Item 5.**Development Application: 38-44 Mountain Street, Ultimo - D/2020/1288**

File No.: D/2020/1288

Summary

Figure 23: West elevation, Mountain Street (as lodged)

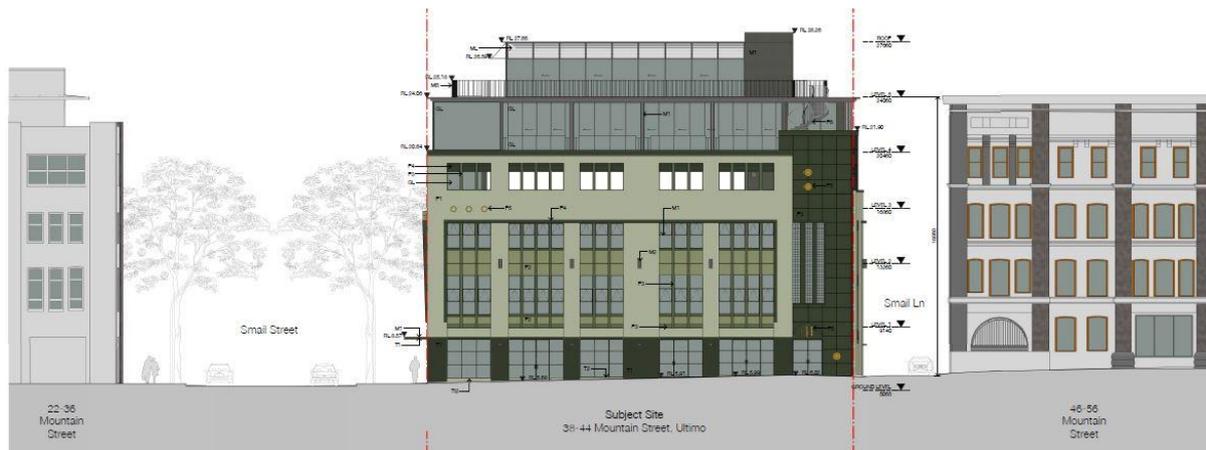
22. The proposal has been amended in response to feedback regarding heritage impacts, and scale and bulk of the proposal. The proposal as lodged included a proposed three storey addition to the existing building as shown in the images below.

23. In response to feedback provided, the application has been amended with the deletion of the six storey office floor space, the roof terrace expanded with additional landscaping provided, and new building massing setback from Mountain Street to express the existing building features. The architectural expression and colour scheme has also been amended in response to heritage feedback. Minor amendments are further recommended as part of a design modification condition for building finishes. Accompanying view studies demonstrate the reduction in bulk to the proposal.
